## Mackenzie South Technology Centre SP 07-70

### **MACKENZIE SOUTH TECHNOLOGY CENTRE, SP07-70**

## PLAN REVIEW CENTER REPORT

SP #07-70

**SITE  
PLAN**

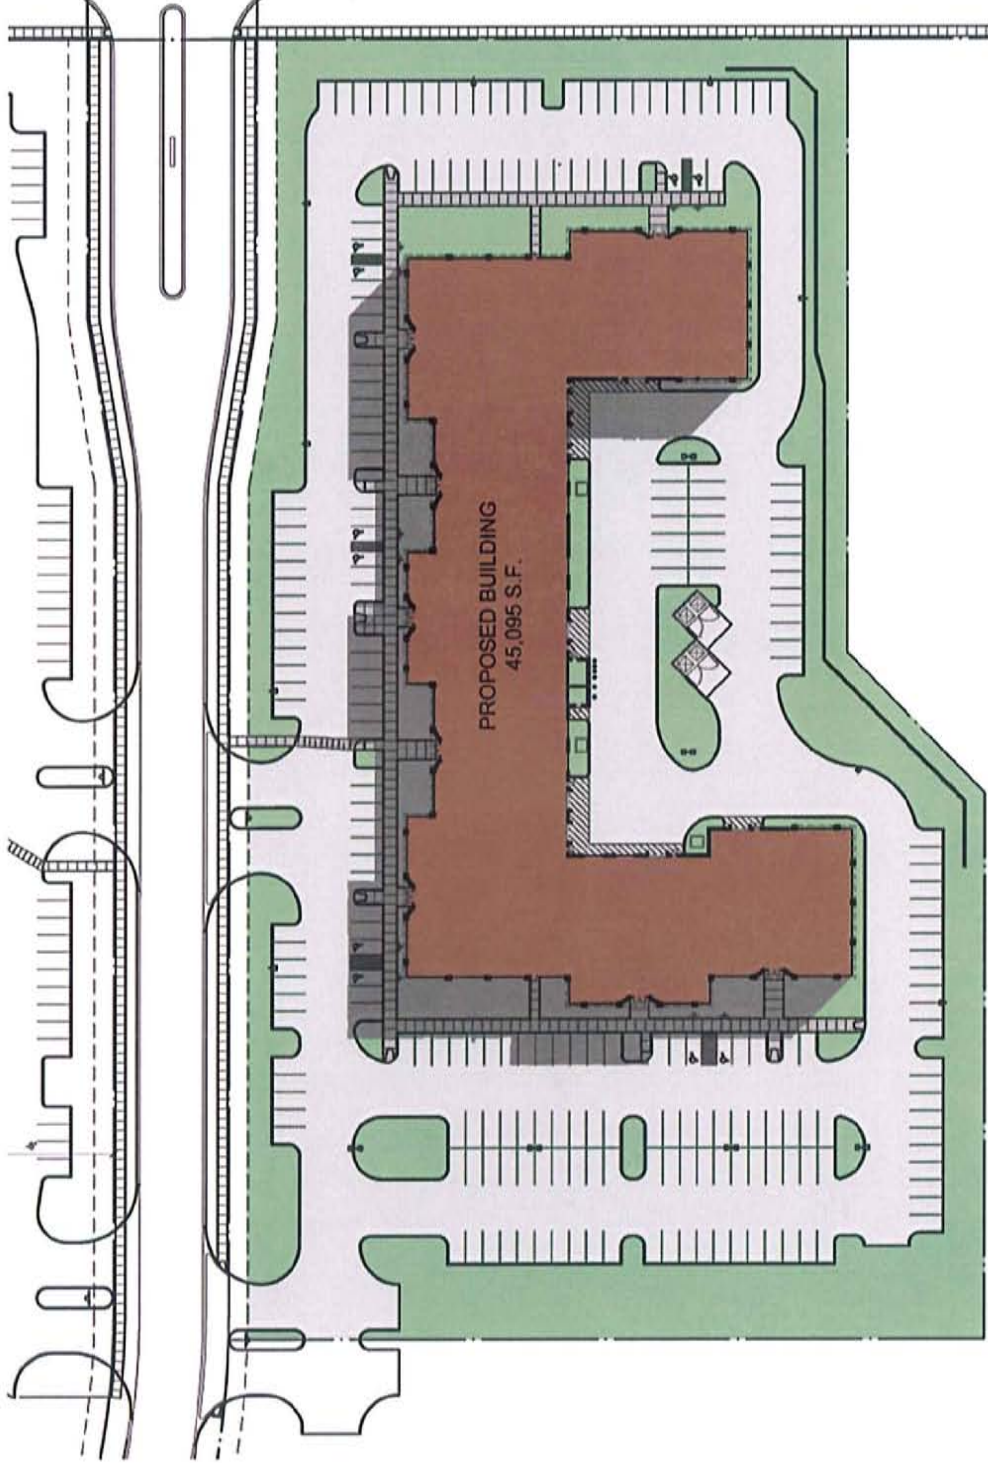
Item	Required	Proposed	Meets Requirements?	Comments
Master Plan	Office	Office	Yes	
Zoning	OST	OST	Yes	
Use	Various office and accessory uses	Single Story office building	Yes	
Building Height (Sec. 2400)	Maximum 46 feet	Maximum approximately 25 feet	Yes	
<b>Building Setbacks (Section 2400)</b>				
Front (north)	50 feet	77 feet	Yes	
Exterior Side (west)	50 feet	172 feet	Yes	
Interior Side (east)	50 feet	98 feet	Yes	
Rear (south)	50 feet	52 feet	Yes	
<b>Parking Setbacks (Section 2400)</b>				
Front (north)	20 feet	22 feet	Yes	
Exterior Side (west)	20 feet	39 feet	Yes	
Interior Side (east)	20 feet	22 feet	Yes	
Rear (south)	10 feet	22 feet	Yes	
Number of Parking Spaces (Sec. 2505)	1/222 sq. ft. GLA = <b>220 spaces required</b>	241 spaces	Yes	<u>This building is not approved for medical office use.</u>
Parking Space Dimensions (Sec. 2506)	9' x 19' parking space dimensions and 24' wide drives.  9' x 17' parking space dimensions and 24' wide drives where 4" curbs are indicated.	9' x 19' parking space dimensions with 24' wide drive.  9' x 17' with 24' wide drives.	Yes	<u>Applicant should indicate 4" curbs where 17' parking spaces are proposed on Sheet SP.101.</u>

- "VAN ACCESSIBLE (R7-8a)" signs should be provided along with the sign "RESERVED PARKING (R7-8)" where the van accessible handicapped parking spaces are provided. Barrier-free parking signs R7-8 and R7-8a are different signs with different messages. Sign R7-8 is always to be provided with all kinds of barrier-free parking spaces and sign R7-8a is to be provided only with "Van Accessible" parking space. Hence, these signs should be appropriately noted on the plans.
- The locations and the quantities for the "NO PARKING FIRE LANE (R7-9a mod)" signs should be clearly stated on the site plan.
- The detail for the "Typical Barrier Free Parking Sign" on SP 102 should be corrected by eliminating the gap between the two signs.

- Corrections should be made in the General Site Notes 8C and 9 on sheet SP 101 to indicate that the minimum width of the curb ramp would be 60" as opposed to 36".

**Parking space dimensions:** 4" curbs have been noted at 17' parking spaces as requested on sheet SP.101.

**Item #5:** The 'General Site Notes' on sheet SP.101 have been corrected as requested.

**HCCP PHASE II LANDSCAPE FEATURE**

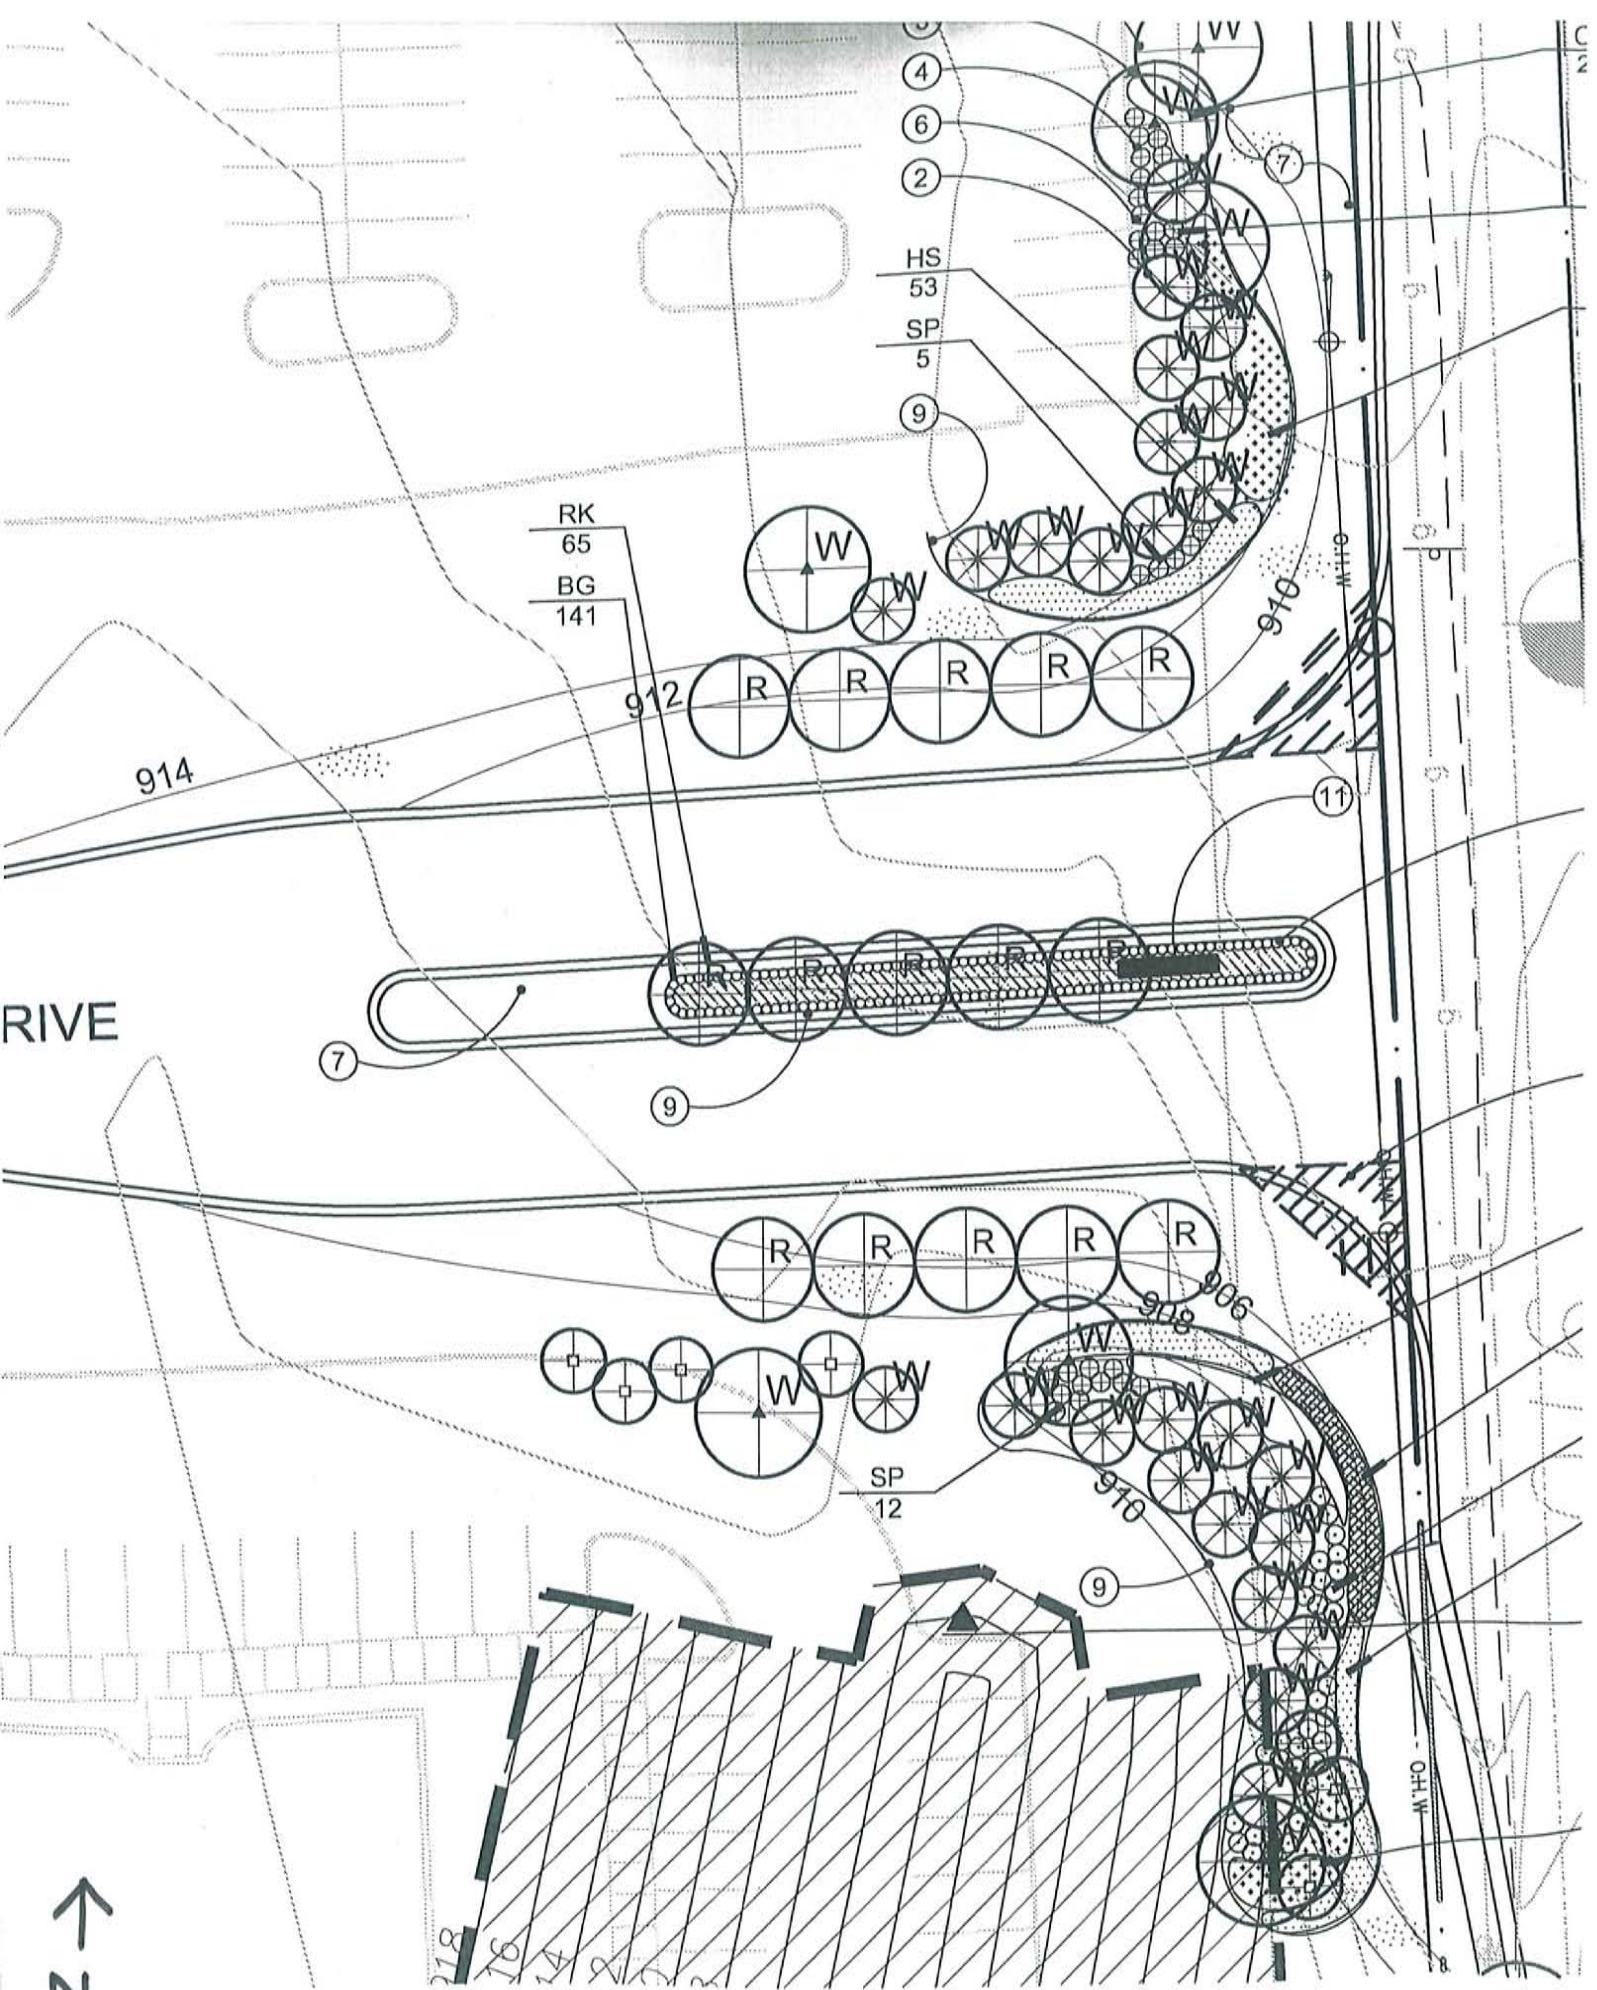
Please also note that the previously approved site plan for the overall development, Haggerty Corridor Phase II, included landscape treatment on this project site. The landscape was designed to provide an attractive entry at Mackenzie and Haggerty Road. A number of the proposed plantings were required Woodland Replacement Trees. The proposed landscape plan for Mackenzie South Technology Centre does not include this landscape. The previously approved entry landscape treatment should be included as part of this plan.
